# **MODIFICATION REPORT**

17-21 Lachlan Avenue & 163  
Herring Road, Macquarie Park

**LACHLAN AVENUE DEVELOPMENT PTY LTD**

20 March 2024

Figure 3 Comparison Between Approved and Proposed Lower Ground Arrangement

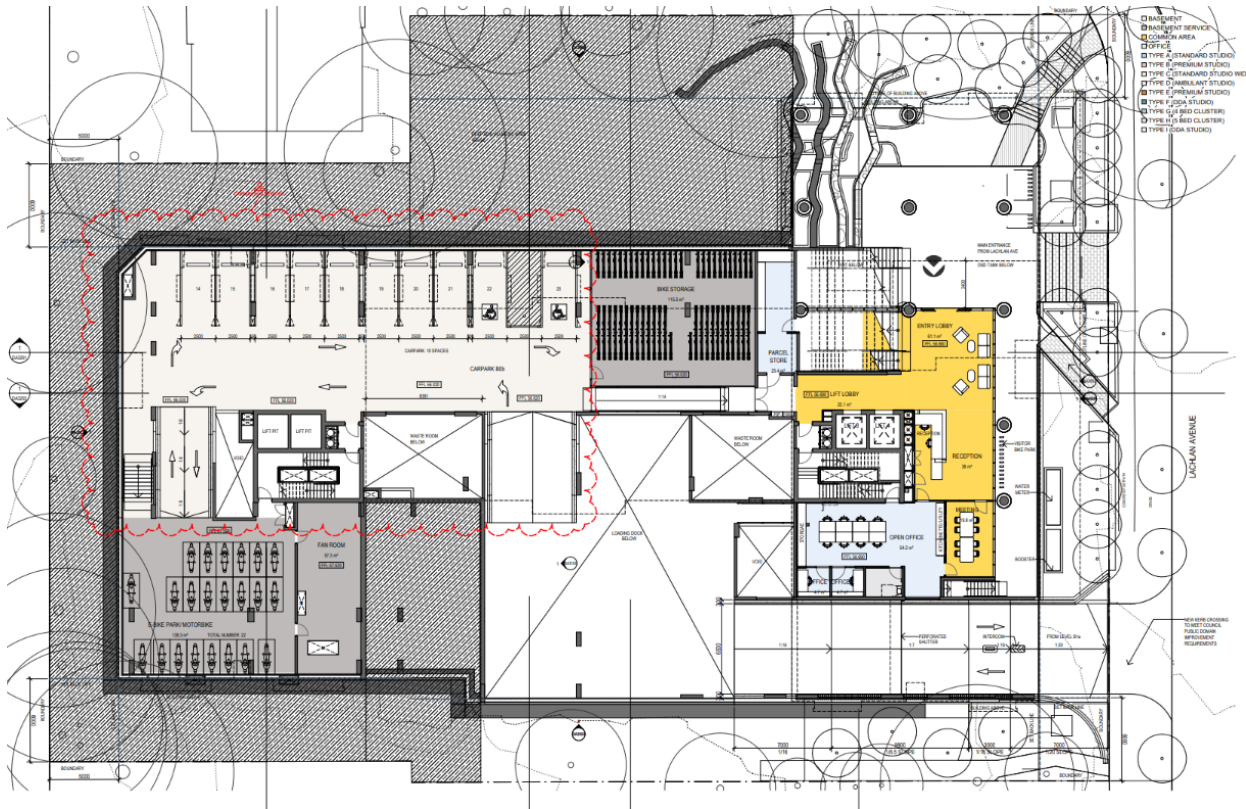
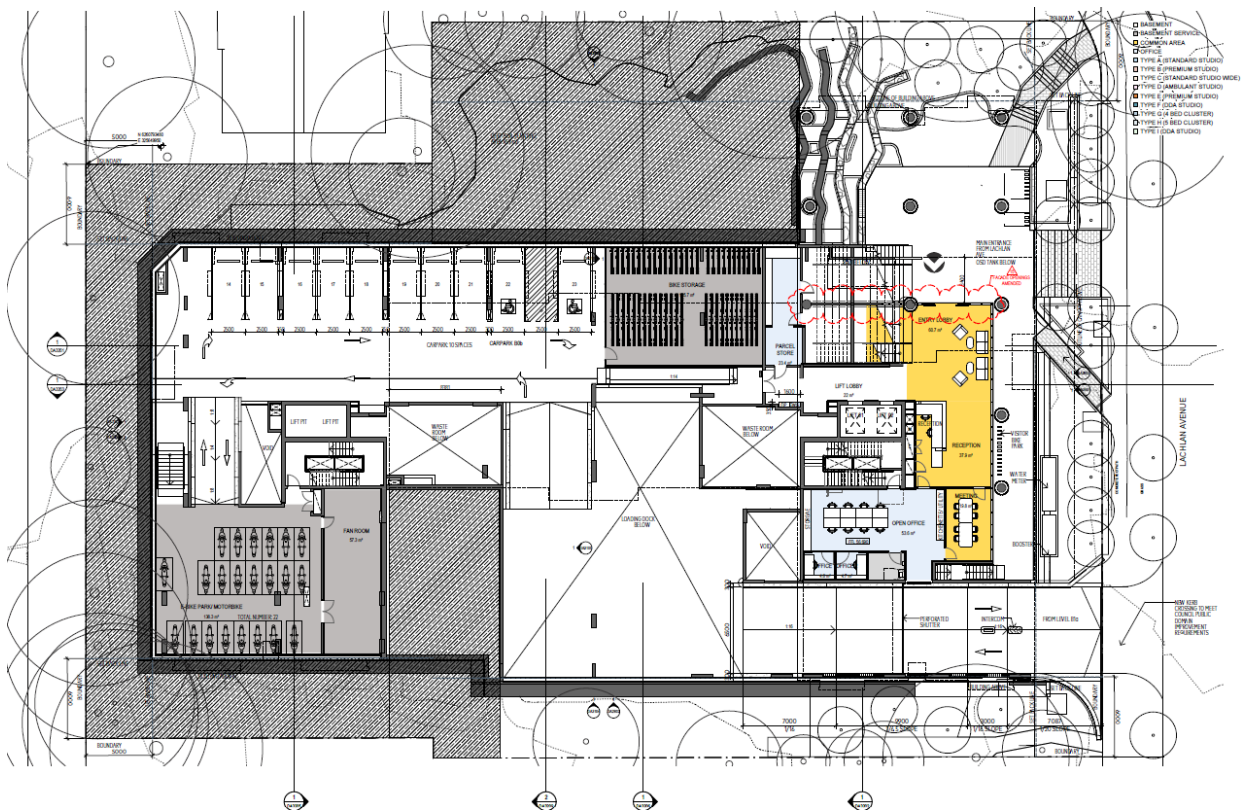
- Materials and finishes across the facades of the building
- Rationalisation of plant and equipment on the roof of the building
- Minor changes to the layout and courtyard canopies at Level 00
- Minor changes to the Herring Road entry at Level 01
- Minor changes to the Lachlan Avenue entry at Lower Ground level

Proposed Amendment	Plan References	Reason for Amendment
Minor amendments to the materials and finishes across the facades of the development as follows: <ul style="list-style-type: none"> <li>▪ Brick finish to courtyard elevations changed to metal finish</li> <li>▪ Façade Type 1 - Changes to the depth and detail of the veil element</li> <li>▪ Façade Types 3 and 7 - Protruding brick feature has been omitted</li> <li>▪ Façade Type 5 - Brick finish to gable ends changed to 3 colour metal panel system</li> <li>▪ Façade Type 6 – Changes to the fin depth and detail, deletion of horizontal fin and some of the vertical fins</li> <li>▪ Central wing canopies at Level 00 changed from glass to solid material</li> <li>▪ Frosted film added to glazing within corridor at Levels 5-12.</li> </ul>	DA0004_6 DA0005_6 DA0006_6 DA0007_6 DA2003_9 DA2004_9 DA3101_7 DA3102_7 DA3103_7 DA3103_7 DA3104_7 DA3105_7 DA3106_7 DA3201_12	The amendments to the facades simplify the construction phase and reflect the value engineering exercise completed for the project by the Project Team. AJC have been consulted in relation the proposed changes to ensure that the development maintains the original design intent established for the project.  The addition of frosted film to the corridor glazing at Levels 5-12 address Condition 1A of the consent.

Figure 5 Comparison Between Approved and Proposed Level 01 Arrangement

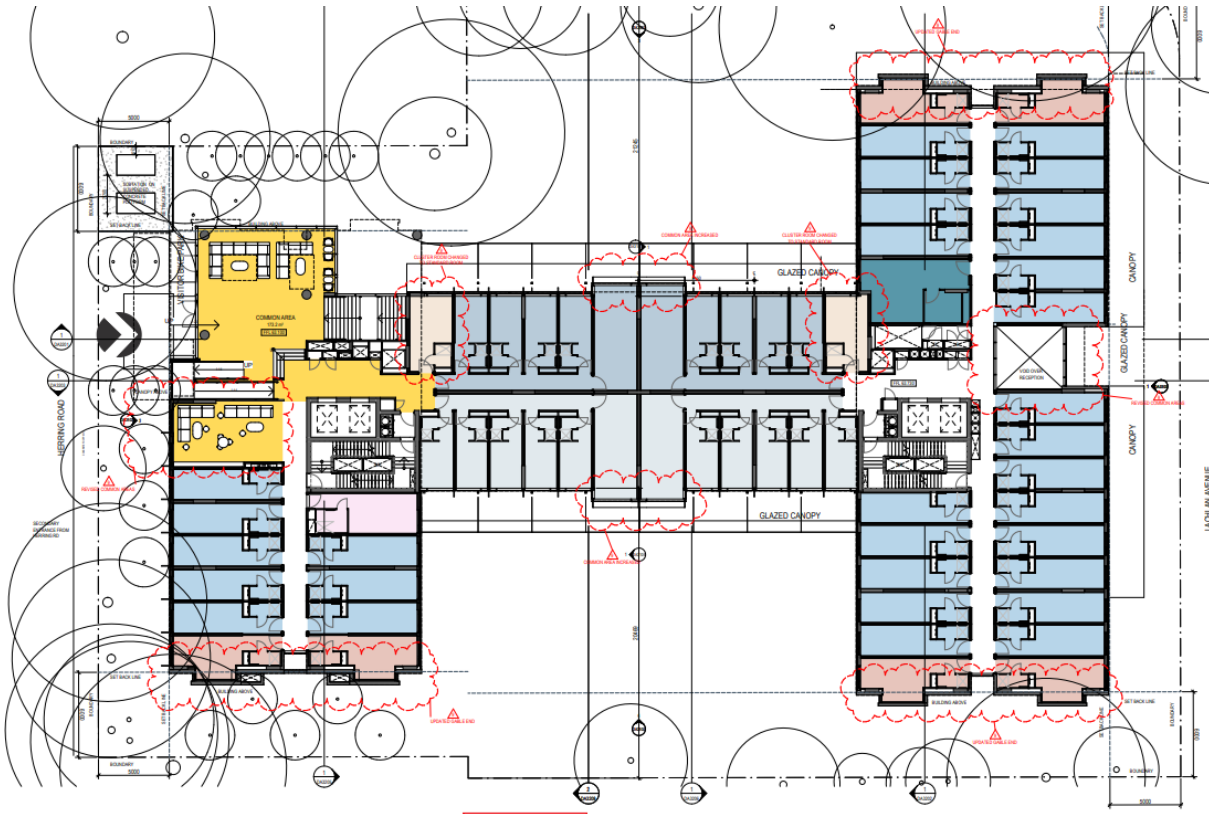
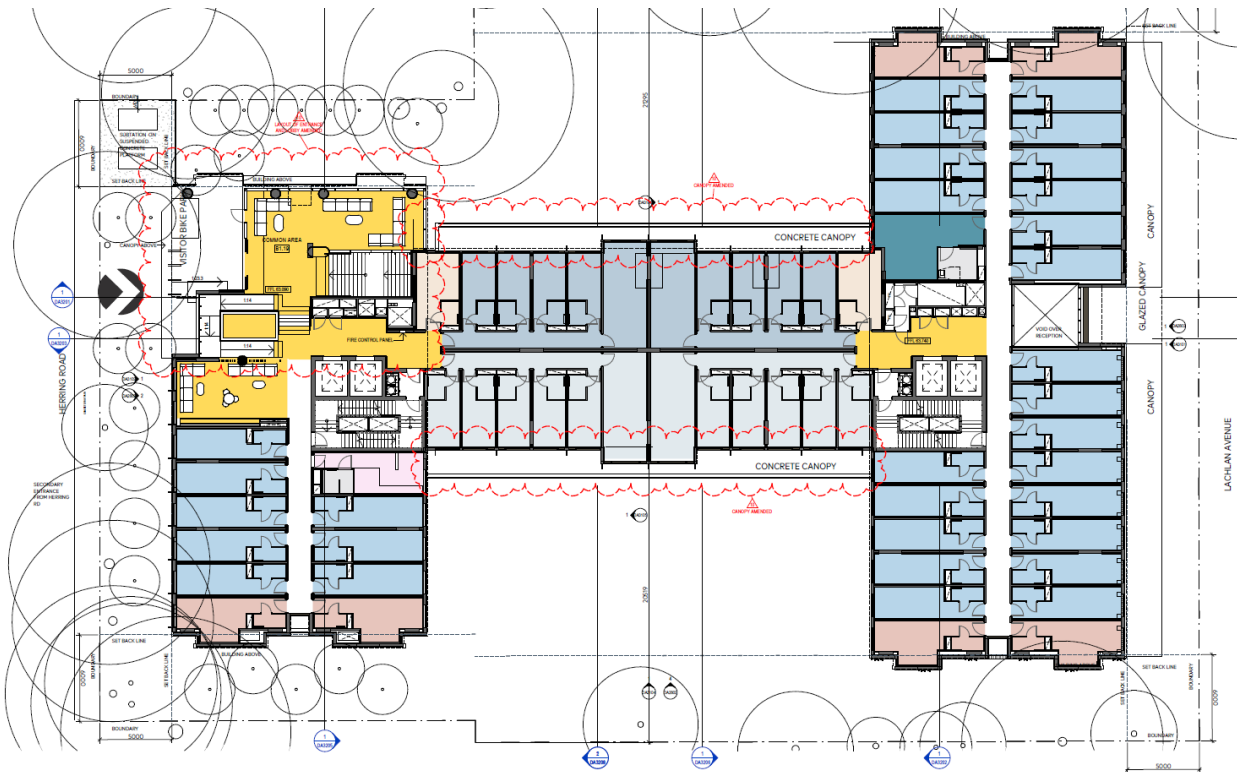
<p>Minor reconfiguration of Herring Road entrance at Level 01 and realignment of entry facade</p>	<p><b>DA2004_9</b></p>	<p>Following feedback from Ausgrid, it has been necessary to setback the pedestrian entry to Herring Road to accommodate the heat zone from the proposed substation.</p> <p>In response, the Applicant has taken the opportunity to improve the layout of the Herring Road entrance at Level 01.</p>
<p>Minor reconfiguration of the plant, laundry, cinema and toilets at Level 00</p>	<p><b>DA2003_9</b></p>	<p>Following feedback from Ausgrid, it has been necessary to shave off the corner of the cinema to accommodate the heat zone from the proposed substation.</p> <p>In response, the Applicant has taken the opportunity to improve the layout of plant and back-of-house facilities at Level 00.</p>
<p>Minor realignment of Lachlan Avenue entry facade at Lower Ground Level</p>	<p><b>DA2002_15</b></p>	<p>The changes to the entry reflect a minor realignment of the structural column setout.</p>

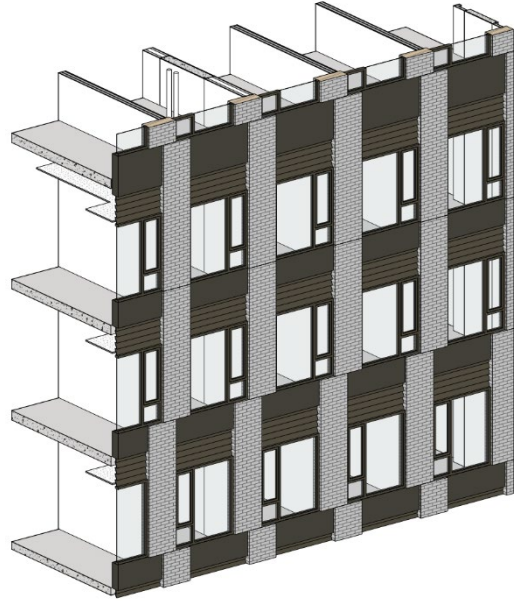
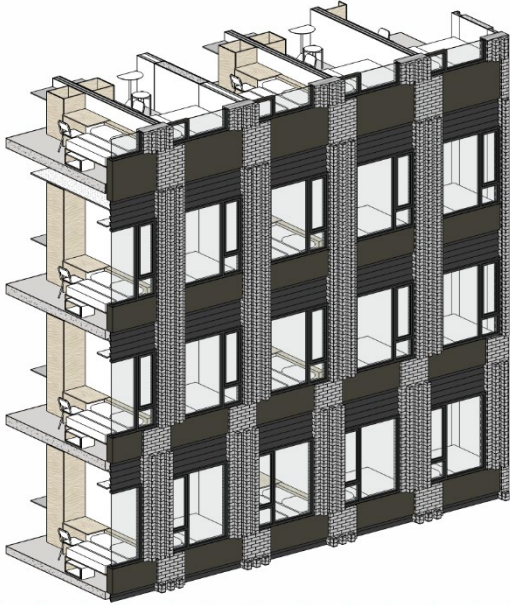
Supported

Proposed minor amendment to glass canopy framing to include supporting structure. Original design intent is retained as per approved version.

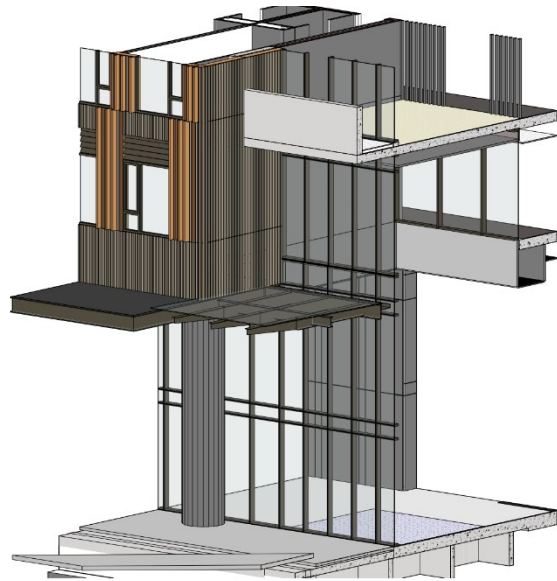
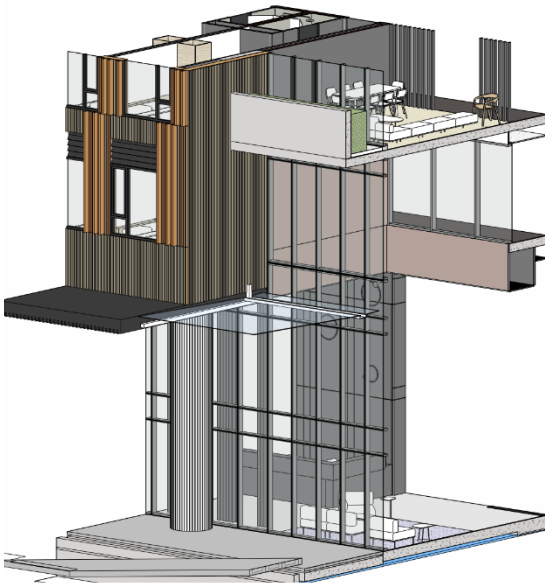
This facade type is described as brick cladding on a 'clip on' system, which may be acceptable, but raises question as to whether the proposal is a rain screen or a weathertight system.

Proposed change of material from brick to metal cladding – design intent is retained with a proposed three colour metal panel system replicating the design and variation to the gable ends previously proposed. Original design intent is retained as per approved version.

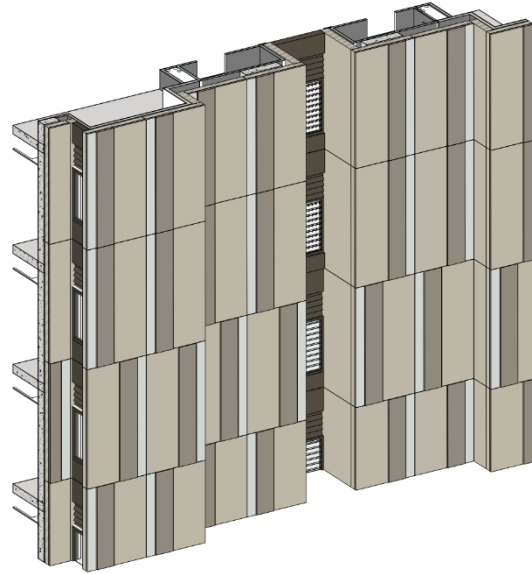
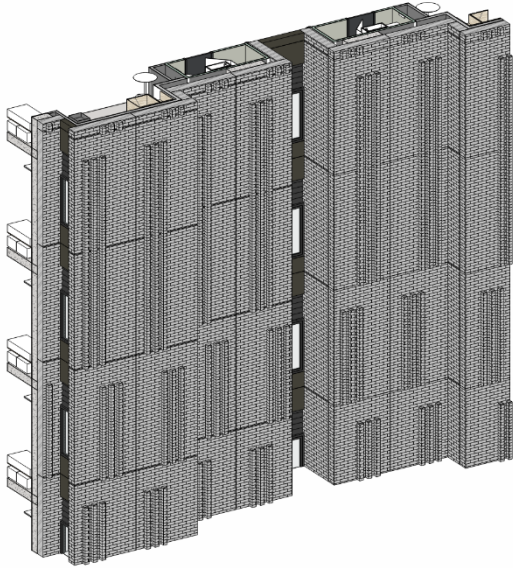
Supported, noting earlier comments that privacy film would be better applied to fixed portions of a window rather than an operable sash. The proposed appearance of the veil in this facade type is acceptable.

Proposed minor amendment to the fin depth and detail, deletion of the horizontal fin, and some of the vertical fins. Change from glass canopy to solid canopy at courtyard level – design intent is retained as per approved version. No changes to the windows, which were amended to address the UDRP’s comments on privacy prior to approval. Vertical fins are retained at the corners of the building to minimise overlooking between rooms.

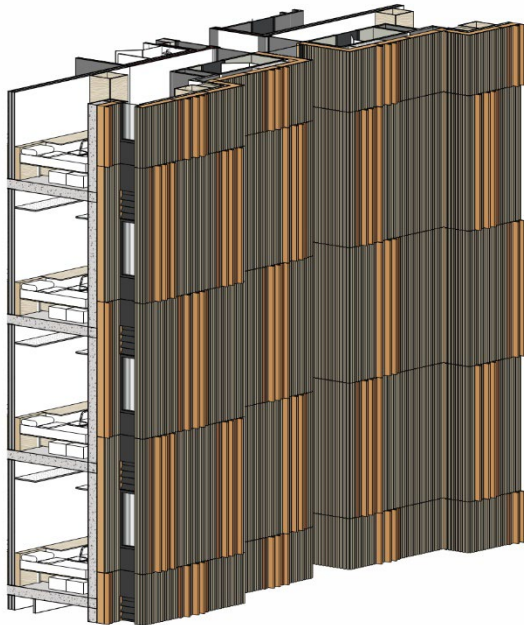
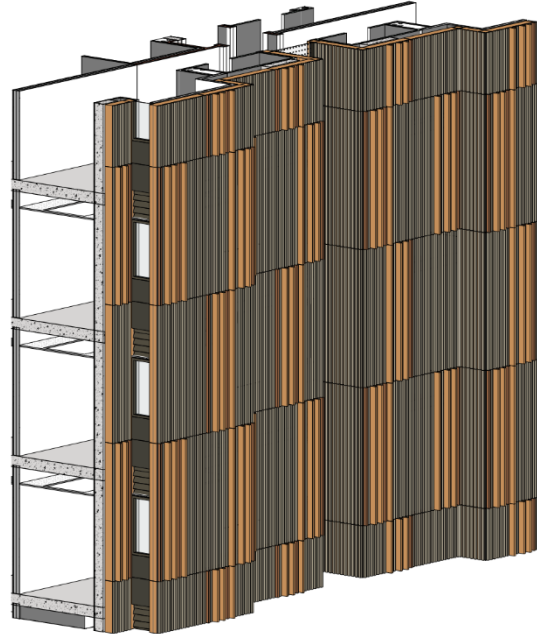
Supported, noting comments from Type 3 are relevant here, particularly where panels are offset between adjacent storeys.

Proposed minor amendment to brick cladding detail to simplify construction by omitting the protruding brick feature. Brick façade retained to Herring Road. Brick changed to metal cladding to internal

courtyard elevation. Original design intent is retained as per the approved version.

Figure 8 Comparison of Height Plane Diagrams for Approved and Modified Schemes

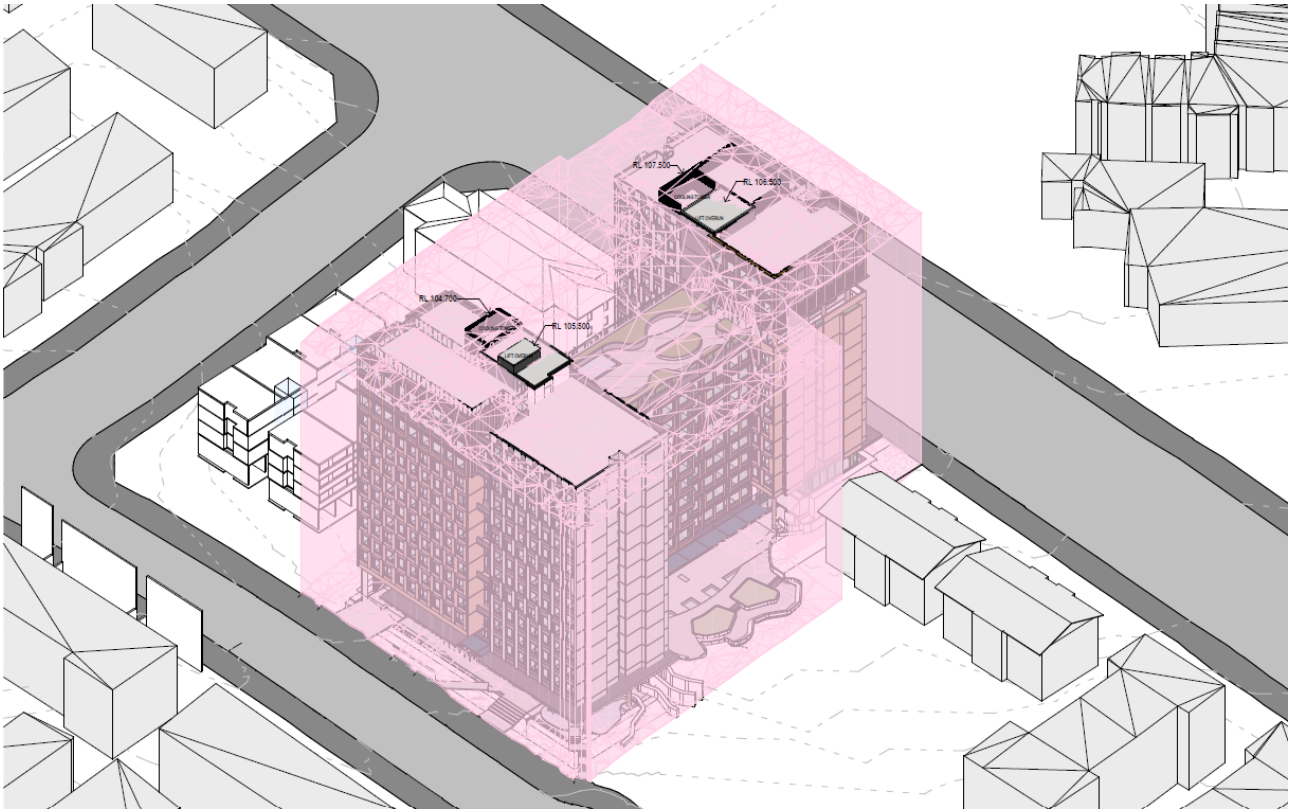
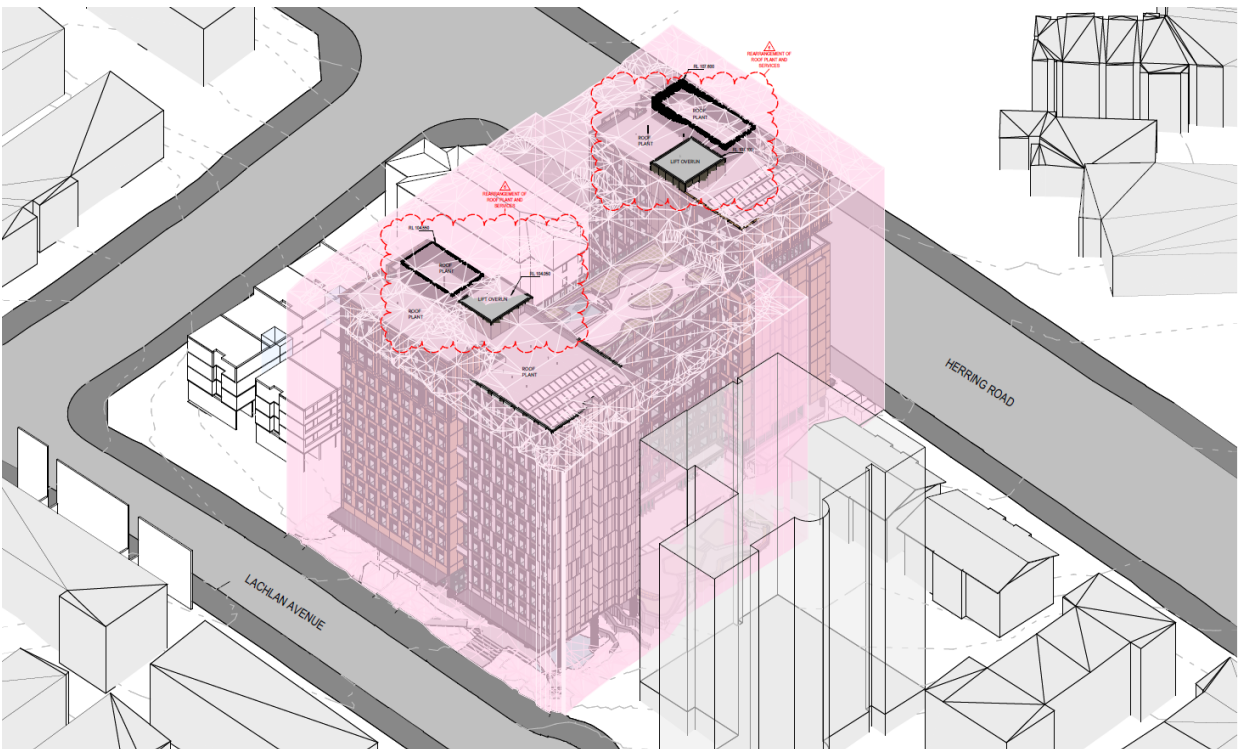
- Lachlan Avenue lift overrun height reduced from RL 105.500 to 104.050
- Herring Road lift overrun height increased from RL106.500 to 107.100
- Lachlan Ave roof plant screen reduced in height from RL 104.700 to 104.550
- Herring Road roof plant screen increased in height from RL 107.500 to 107.600

**Figure 8** provides a comparison of the height plane diagram for the approved and modified schemes. As shown, the development as modified continues to comply with the height control, with the exception of plant screens and lift overruns. These discreet elements are in keeping with the approved variation to the height control by up to 2.36m to the top of the roof plant. Given the minor changes to the rooftop plant, it is considered that the Clause 4.6 Variation Request that supported the approved development remains relevant to the modified proposal. This request concluded that it is reasonable and appropriate to vary the maximum height standard by up to 2.36m for the following reasons:

The minor increase in the height of the Herring Road lift overrun and plant screening by up to 0.6m will have a negligible increase in overshadowing as shown in the Sun Eye Diagrams that accompany the amended architectural package. Furthermore, the revised roof top plant is set back from the parapet and will not be visible from the public domain or neighbouring residential properties.
